Executive Director's Recommendation

Commission Meeting: October 4, 2018

PROJECT National World War I Memorial Pershing Park Washington, DC	NCPC FILE NUMBER 7682
SUBMITTED BY United States Department of the Interior National Park Service	NCPC MAP FILE NUMBER 1.23(73.10)44812
REVIEW AUTHORITY Commemorative Works per 40 U.S.C. § 8905 and Public Law 113-291	APPLICANT'S REQUEST Approval of comments on revised concept plans
	PROPOSED ACTION Approve comments on revised concept plans
	ACTION ITEM TYPE Staff Presentation

Comments on Concept Design

Flagstaff Options

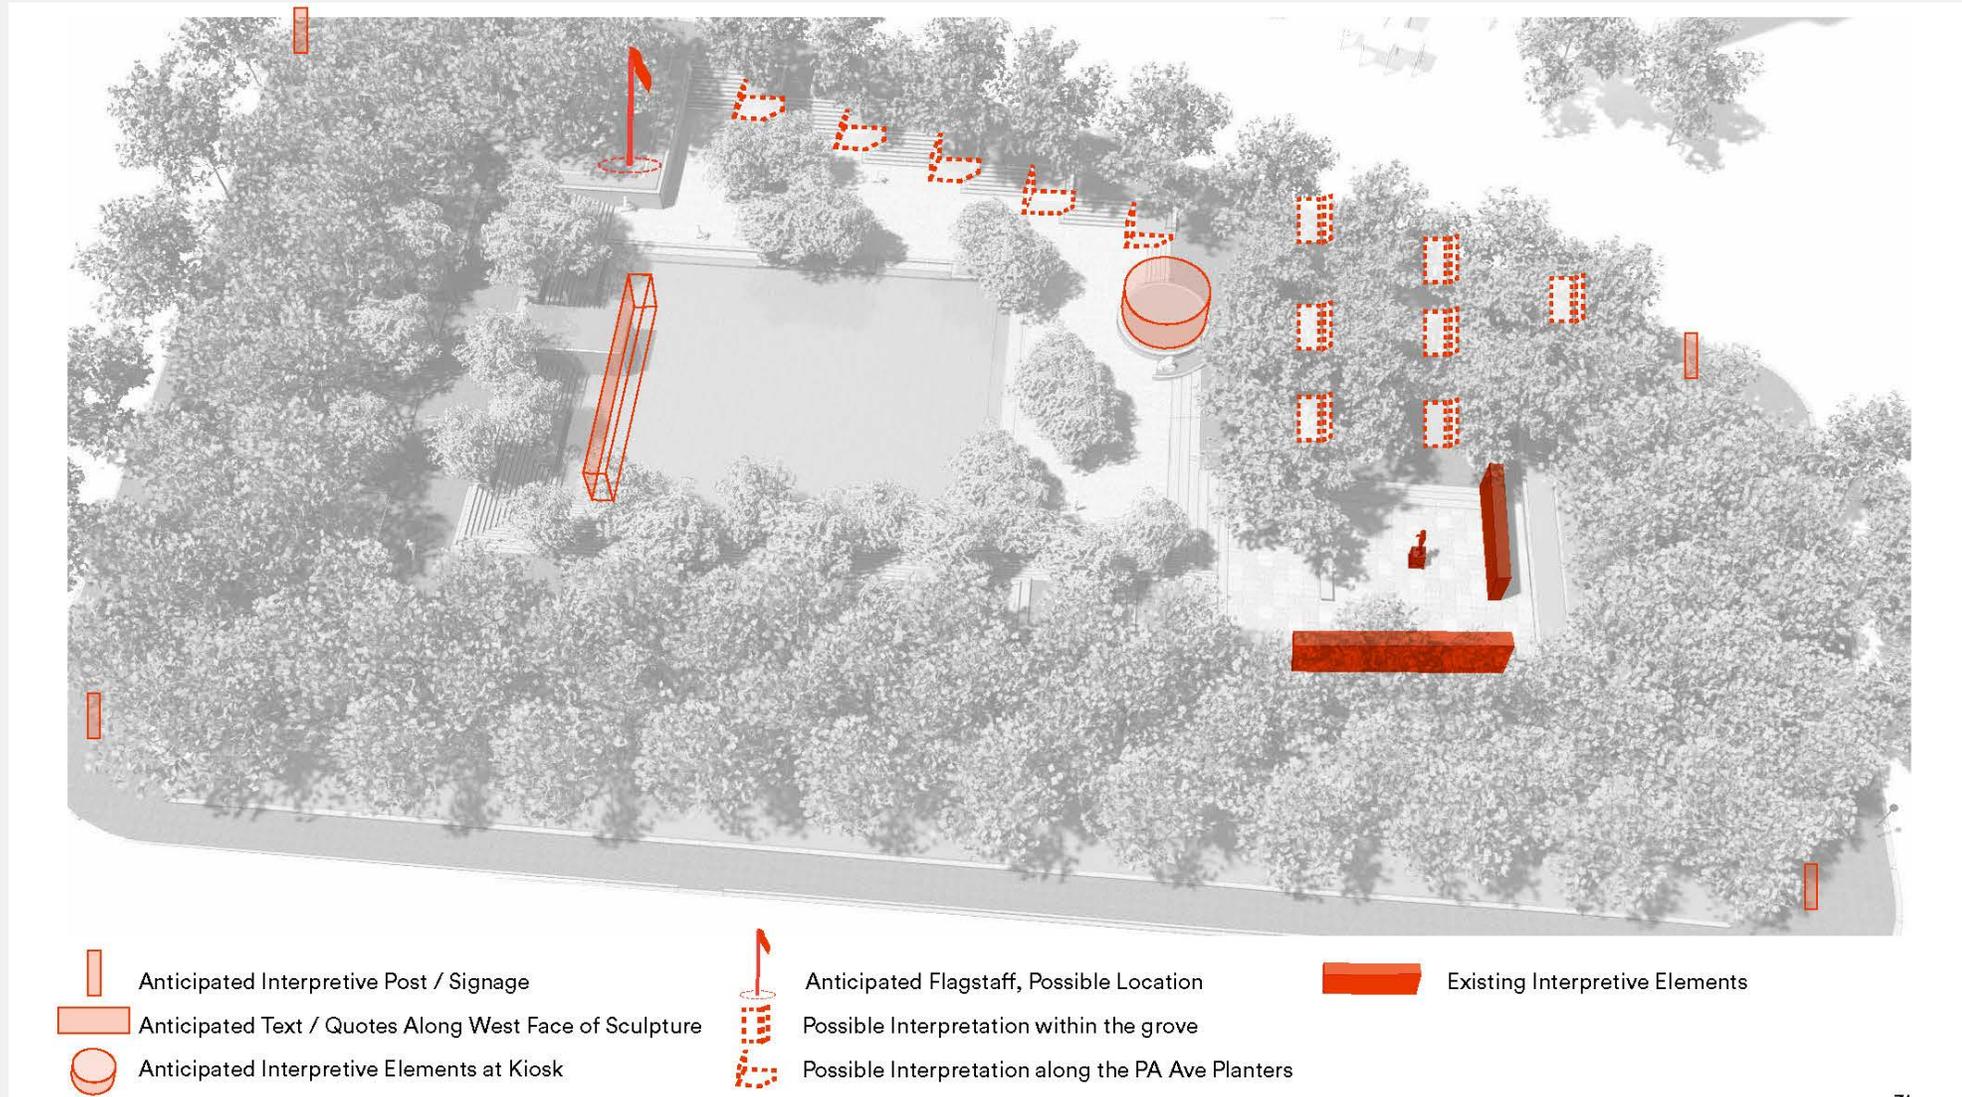
Staff finds that the kiosk site is an appropriate location for interpretive elements related to the memorial given its direct view of the memorial wall across the pool, as well as its centralized location. Further staff finds the north berm location is an appropriate for a flagpole given its locations just to the right of the memorial wall. Regarding the other locations for additional commemorative elements, staff believes they are unnecessary and would detract from use of the rest of the site as an urban park. As described previously, the site should accommodate both park and memorial components, and expanding the memorial program across the entire site would be counter to that goal. As such, staff recommends the **Commission find that the commemorative elements should largely be limited to the memorial wall, kiosk area, and existing Pershing Memorial to highlight their importance and to allow for other types of park uses within the site.**
